REPAIR **SEWAGE PERMIT APPROVAL**

Property Address: ~~1592~~ 1502 S. 4th Ave. Town Kelso

APPROVED FOR: Repair of existing threebedroom dwelling spptic system

SUBJ: Rough layout of replacement drainfield @ 1502 S. 4th Kelso

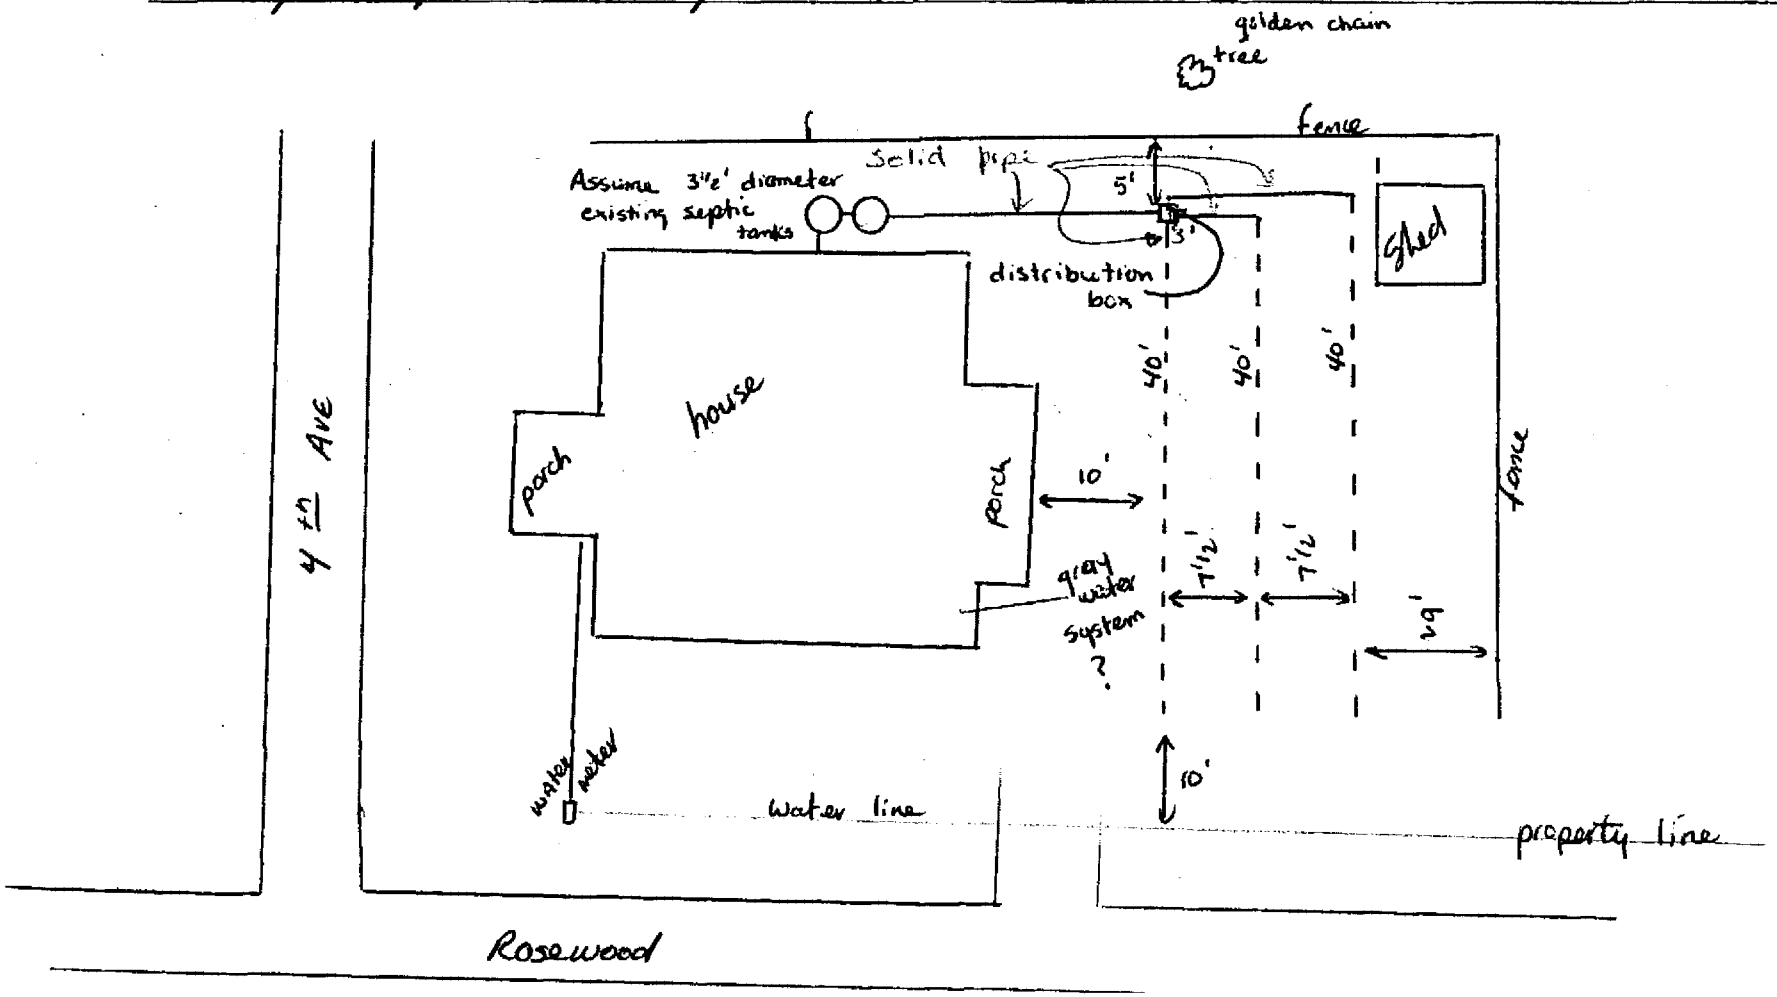
1/ Outlet baffle on septic tank shall extend 20% into liquid depth of tank.
2/ ~~Trench bottoms shall remain level and not be driven nor grazed upon at~~ any time.
3/ Perforated drainpipe shall be installed level to no more than 2½ inches ~~of drop per 40 ft. length.~~
4/ See attached sketch for rough layout of proposed replacement drainfield.
5/ Drainfield shall remain a minimum distance of 10 feet from all water lines ~~under pressure.~~
6/ Call for final inspection prior to backfilling the installation.
